SUBJECT: ISSUANCE OF AMENDMENT NO. 29 TO FACILITY OPERATING LICENSE NPF-68  
AND AMENDMENT NO. 10 TO FACILITY OPERATING LICENSE NPF-81 - VOGTLE  
ELECTRIC GENERATING PLANT, UNITS 1 AND 2 (TACs 74127/74128)

ATTACHMENT TO LICENSE AMENDMENT NO. 29

SAFETY EVALUATION BY THE OFFICE OF NUCLEAR REACTOR REGULATION  
RELATED TO AMENDMENT NO. 29 TO FACILITY OPERATING LICENSE NPF-68  
AND AMENDMENT NO. 10 TO FACILITY OPERATING LICENSE NPF-81

VOGTLE ELECTRIC GENERATING PLANT, UNITS 1 AND 2

FIGURE 3.1-3  
 ROD BANK INSERTION LIMITS VERSUS THERMAL POWER

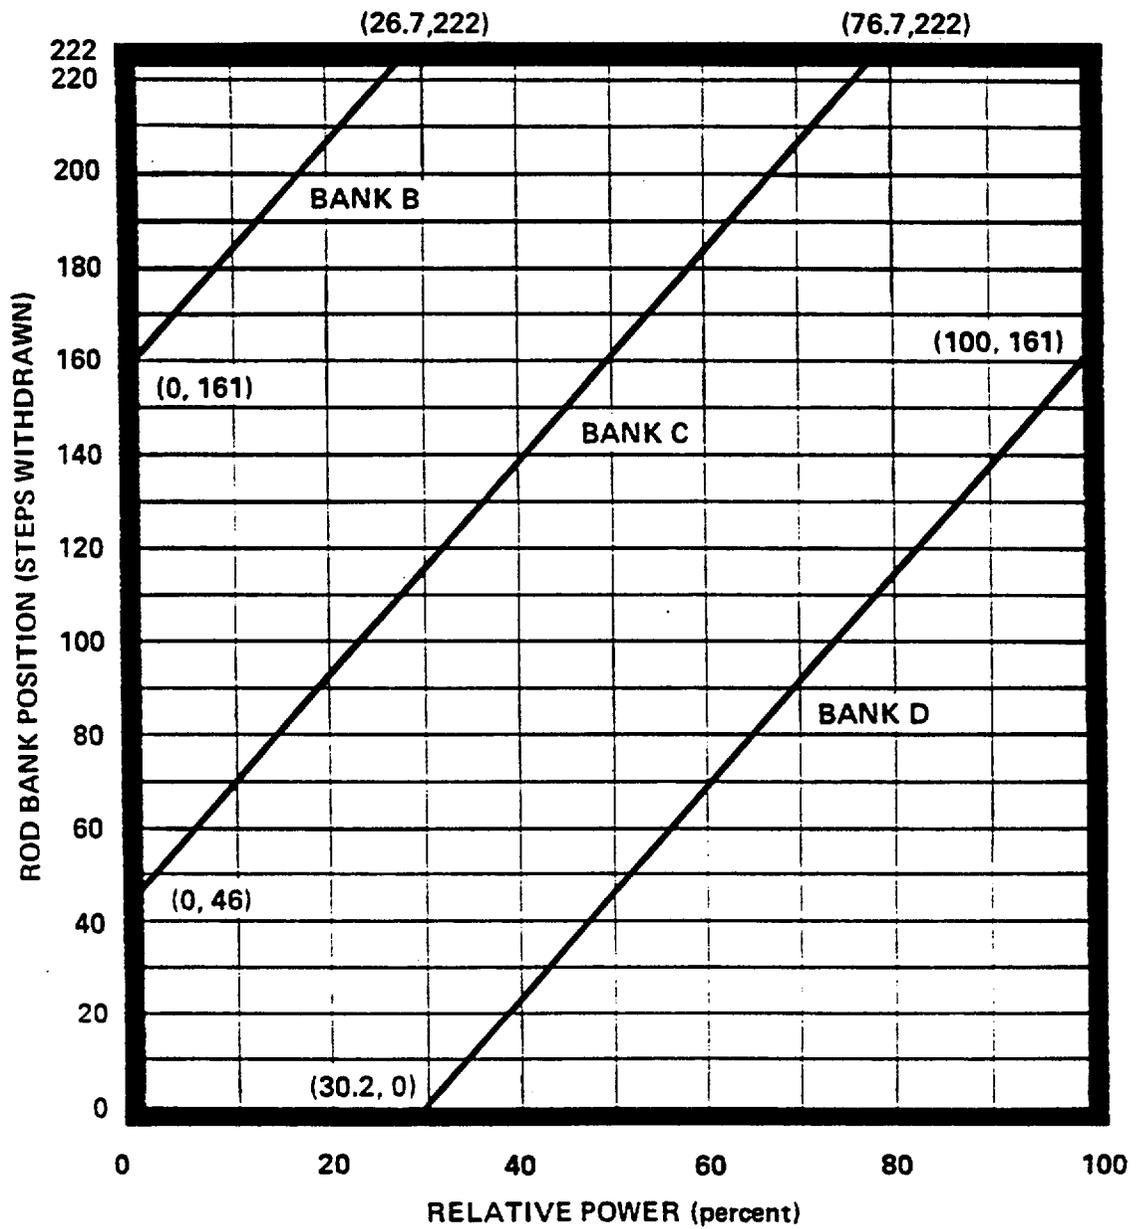
The amendments will revise the rod insertion limits to allow a withdrawn range of 222 steps to 231 steps. The change minimizes control rod wear caused by fretting against upper internal control rod guide surfaces. Additionally, the amendments revise the TSs to allow the use of an absorber material of either hafnium or silver-indium-cadmium.

By letter dated August 25, 1989, Georgia Power Company, et al. (GPC or the licensee) requested changes to the Technical Specifications (TSs) for the Vogtle Electric Generating Plant (VEGP), Units 1 and 2. The proposed changes to the TSs would revise the rod insertion limits of Figure 3.1-3 to show the fully withdrawn position as 222 steps instead of 228 steps. The purpose of the change in the insertion limit is to allow a periodic change, within the range of 222 to 231 steps withdrawn, of the parked full out position of the control rods which will minimize the effects of control rod wear caused by fretting against upper internal control rod guide surfaces. Specification 3.1.3.4 would also be revised to assure that control rod drop time measurements are made from the physical fully withdrawn position (231 steps withdrawn). In addition, a revision to TS 5.3.2 is being proposed that would indicate that control rods may utilize an absorber material of either hafnium or silver-indium-cadmium. The use of either type of absorber material was described in the VEGP Final Safety Analysis Report (FSAR) and in the NRC's Safety Evaluation Report related to the operation of VEGP. However, Section 5.3.2 of the TSs only described hafnium since that was the only absorber material in use at the time that the VEGP Units 1 and 2 licenses were issued. Current plans are to replace control rods with absorber material of hafnium with control rods that use silver-indium-cadmium, beginning at the next refueling outage which is scheduled for VEGP Unit 1 in the Spring of 1990.

For Vogtle, the current control rod parked withdrawn position is 228 steps, while the physical limit to rod withdrawal is 231 steps. The proposed change will revise the TSs to allow withdrawn parked positions between 222 and 231 steps to further minimize the wear problem and to lengthen the control rod lifetime.

The licensee evaluated the non-LOCAs (loss of coolant accidents) and LOCAs that could be affected by the proposed change in rod insertion limit. The results show that the change in rod insertion limit (between 222 and 231 steps) will not: (1) increase the probability of an accident previously evaluated in the FSAR, (2) increase the consequence of an accident previously evaluated in the FSAR, (3) create the possibility of a new kind of accident, or (4) decrease the safety margin. Both the licensee's evaluation and the proposed TS changes to allow for withdrawn parked positions between 222 and 231 steps are acceptable for Vogtle Units 1 and 2.
